**NORTHEAST UTILITIES**

April 6, 1984

Millstone Nuclear Power Station, Unit No. 3  
Submittal of Revised Responses to PSB  
Mechanical Series Questions

Enclosure 3, of Reference (1) requested additional information beyond responses provided to Reference (2). Attached is a portion of those revised responses. These revised responses appear as they will in our next amendment. Attachment 1 contains the following revised responses:

FIGURE 3.8-66 (SHEET 1 OF 5)  
EMERGENCY GENERATOR ENCLOSURE  
MILLSTONE NUCLEAR POWER STATION  
UNIT 3  
FINAL SAFETY ANALYSIS REPORT

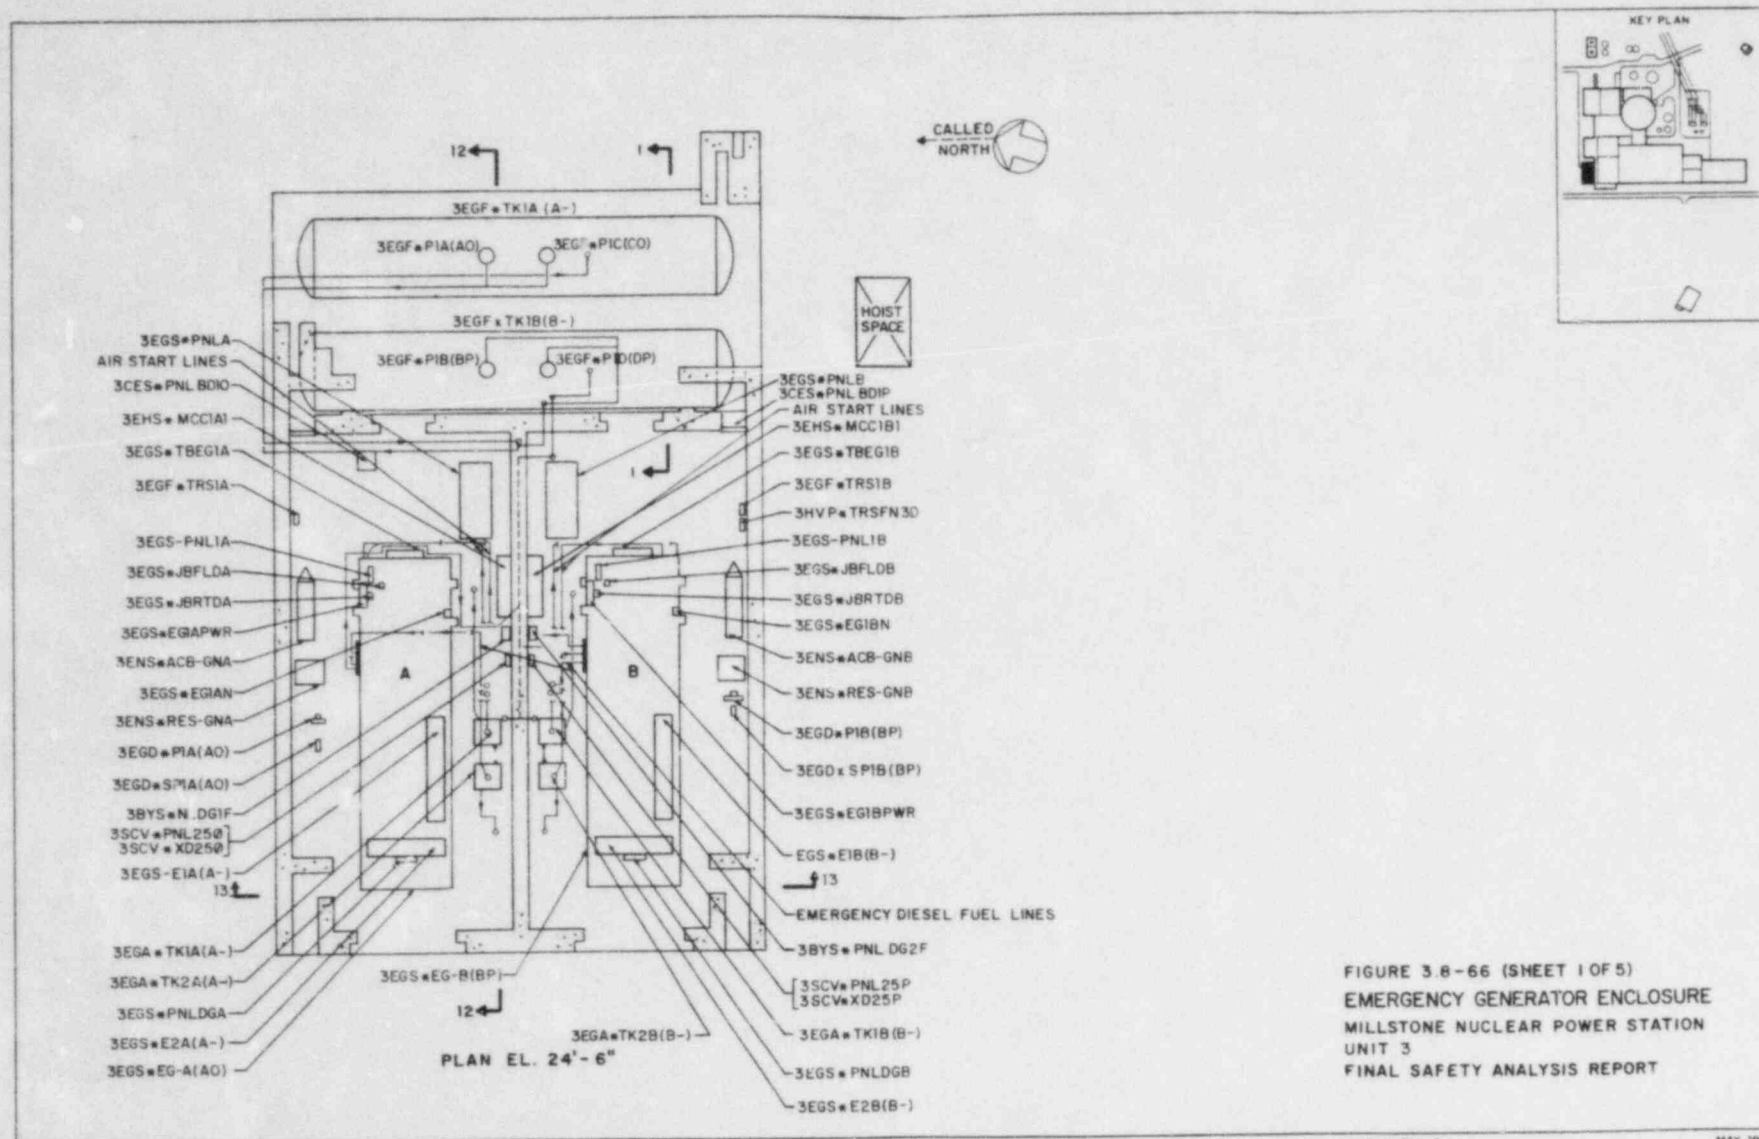
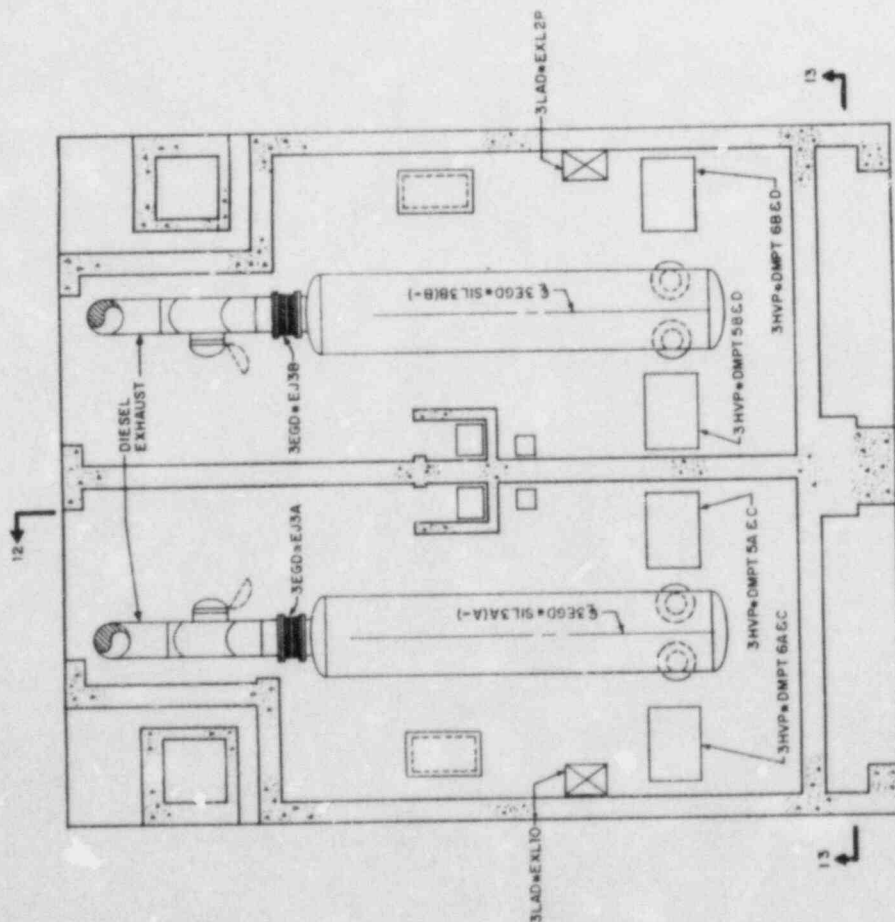
Section 1.2 of the FSAR does not provide any plant plan or elevation drawings. These drawings are necessary to evaluate the adequacy of the diesel generator equipment and its facility with regards to conformance with General Design Criteria 2, 4, 5, and 17 and the Regulatory Guides, NUREGs, and other acceptance criteria in the Standard Review Plans. Provide a plot plan and plan, elevation and sectional elevation drawings of the Millstone emergency diesel generator facility. The drawings shall include: location of the diesel generator and its components (pumps, tanks, air receivers, etc), details and location of the air intake and exhaust structures, locations of any gas (hydrogen, nitrogen, CO<sub>2</sub> etc) tanks located on site, locations and heights of surrounding buildings, and routings of major piping systems within the diesel generator facility (fuel oil, air intake and exhaust systems).

Provide cross reference between equipment names and equipment tag numbers shown on Figure 3.8-66.

Refer to revised FSAR Figures 1.2-2 and 3.8-66 for the response to this question.

FIGURE Q430.73-4  
PIPING CLASSES OF THE AIR  
START SYSTEM  
MILLSTONE NUCLEAR POWER STATION  
UNIT 3  
FINAL SAFETY ANALYSIS REPORT

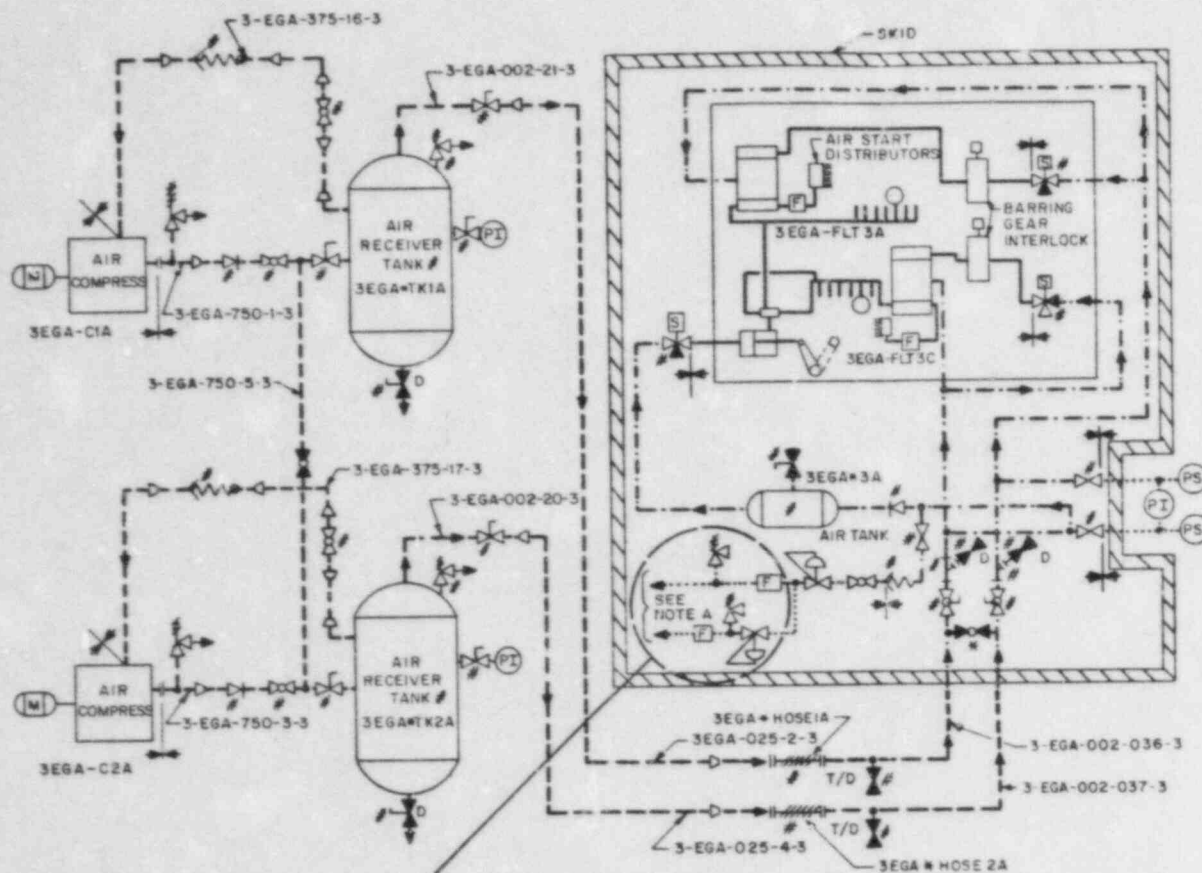
You state in the FSAR that protection from high and moderate energy pipe breaks is discussed in Section 3.6.1. Section 3.6.1 only identifies the fuel oil system as a moderate energy system and does not provide any analysis for that system. This is unacceptable. Identify all high and moderate energy lines and systems that will be installed in the diesel generator room. Discuss the measures that will be taken in the design of the diesel generator facility to protect the safety related system, piping, and components from the effects of high and moderate energy line failure to assure availability of the diesel generator when needed. (See request 430.110 for additional concerns on high energy line breaks with regard to the air start system.)

A review of the high energy air start system on the emergency generator will be performed in accordance with the acceptance requirements of FSAR Section 3.6. The definition of loss of offsite power coincident with postulated piping failure found in FSAR Section 3.6 has been revised to reflect the assumptions of BTP ASB 3-1, Paragraph 3.b1 to clarify postulated events.

Corrective measures will be taken if the review determines that pipe breaks in this system do not meet the acceptance criteria of FSAR Section 3.6.

The piping and component classification of the high energy air start system is shown on revised Figure Q430.73-4. All other diesel generator auxiliary systems, lube oil, jacket water, intercooler water, and control air are considered moderate energy systems. Their piping and component classifications are shown on Figures Q430.73-1 through Q430.73-4. The effects of moderate energy pipe breaks are considered negligible.
